Quanta Computer Inc.
PROJECT : Z6B

PROJECT : ZGB

Model	REV	CHANGE LIST	MODEL	ZGB	
ZGB MB				FROM	To
				X	2A
A1 (V1.0)		page 29 :Change PQ33 to PQ43,PQ44 for CPU change to dual core.			
		page 29 : change PC75 from 220uf to 330uf. because dual core CPU need adjustment.			
		page 29 : change PC111 from 330uf to 220uf because dual core CPU need adjustment.			
		page 29 : change PR151 from 1.8k to 10k because dual core CPU need adjustment.			
		page 29 : change PR156 from 1.6k to 1.8k because dual core CPU need adjustment.			
		page 29 : change PR154 from 1.1k to 2.7k because dual core CPU need adjustment.			
		page 29 : change PC47 from 0.1uf to 0.22uf because dual core CPU need adjustment.			
		page 29 : change PR82 from 1.2k to 4.02k because dual core CPU need adjustment.			
		page 29 : change PR88 from 15k to 13k because dual core CPU need adjustment.			
		page 29 : change PR76 from 18k to 12.7k because dual core CPU need adjustment.			
A1 (V1.1)		page 29 : change PR57 from 53.6k to 60.4k because dual core CPU need adjustment.

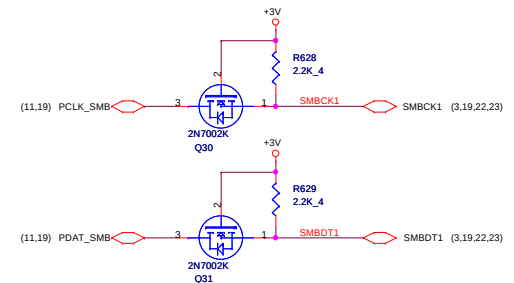
no connect FSA to CPU, due to there is no FSA PIN for CPU.
need to check check how to handle it in CPU CLK_BESEL0

CAMERA POWER(CCD)

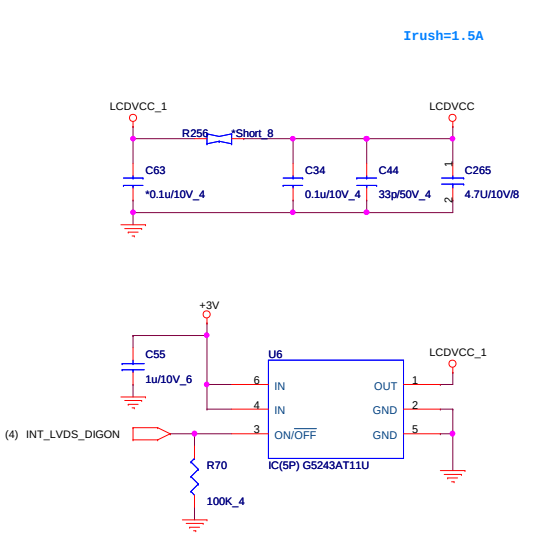
page 2 : change CLK GEN from SLG85P513VTR to SLG8LV631VTR for power saving.			
		page 11: change RTC from connector to socket for SMT request.			
		page 23: TPM change to Infineon replacement R428,R38,R433,C77,R83,R82,R96,R431,C756,C765,Y7,R432			
		page 29 : change net name VCC_CORE to VCC_CORE_1 for net name adjustment.			
		page 17 : Add debug port 40pin for customer request.(2011/02/27)			
		page 09 : Delete 10pin debug port and add test point on PCH debug pin.(2011/01/31)			
		page 15 : Base on customer request Reserve BT circuit.(2011/02/01)			
		page 17: CN23 add test point Pin7,8,11,12,13,21,27,28,29,35,36,37,38,39 for NC pin.(2011/02/01)			
		page 21: Add 0ohm on SMB clk and SMB Data for test use.(2011/02/01)			
A1 (V1.2)		page 15: Add PCH SMB CLK and data to TP SMB clk and data and additional MOS to prevent electric leakage for reserve test use.(2011/02/01)			
		page 14: Add +5V CCD power for OV9726 CCD and reserve +3V CCD power.(2011/02/01)

page 14: Change to +3V CCD power and reserve +5V CCD power.(2011/02/01)			
		page 23 : 1.remove break net U8.10 to U8.24. 2.R96->NI, change R92 to pull to +3V_S5 (leave NI)3.populate Y7C756/C765/R605. R606->1M, C756/C765->12pF4.populate R428, populate R431. Change R431 pull to +3V_S5.5.add populated 0R jumper U8.28 to U20.G22, change R108 pullup to +3V_S5			
		page 17: R359-361, R363, R366 are not required remove CN23 Pin7,8,11,12,13 connector to KBC EC ROM. CN23 Pin22 connector to SYS_SHDN#(2011/02/10)			
		page 14 : add resistor between Rom and Tigerpoint of U20 pin M8(2011/02/10)			
		page 21 : add resistor between SPI Rom and KBC of U7pin 90.Remove 0ohm on U7 pin71.72. because separate I2C circuit.2011/02/10)			
		page 15 : Add a connector and circuit for TPD I2C circuit, but SPEC acer not yet confirm.(2011/02/10)			
		page 15 : Follow up synaptic pin define modify TPD I2C circuit.(2011/02/11)

TOUCH PAD(TPD)

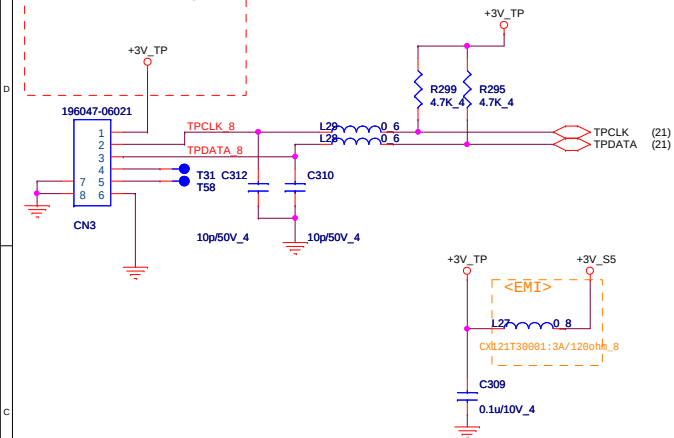
2011/3/28 Remove 4pin connector

page 15 : Remove CN8 TP 4pin.(Following Google suggestion use 6pin connector.)			
		CN6 from DFHD05MRD98 to DFWF05MRD42 and BT power plant from +3VPUC to +3V_S5.(Follow acer AVAP to use new BT ,so we have to use new connector. Correct wrong BT power supply.)			
		page 16 : R16/R17 add 0ohm for EMI.(EMI request)			
		page 26 : Remove vcore jump (those R for power consumption measurement, we won't use they after A stage.)			
		R615,R176,R148,R351,R280,R279,R281,R298,R207,R202,L30,R194,R329,R141,R256,R46,R56,R44,R254,R255, R125,R124,R131,R17,R16,R258,R324, R98,R256,R210,R337,R287,R196,R292,R293,R198,R199,R217,R216,26 4,R382,R73,R443,R444,R74,R78,R400,R433,R83,R370,R376, (Change 0ohm to short pad.(those R for power)consumption measurement, we won't use they after A stage.)			
		page 15 : add R261 and C410 for BT soft star.			
		page 11 : change R152/210 power plant from +3V to +3V_deg.(for google suggestion.)

BLUETOOTH(BTM)

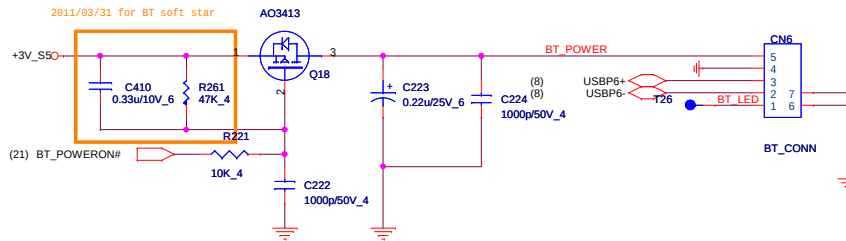
2011/03/31 for BT soft star
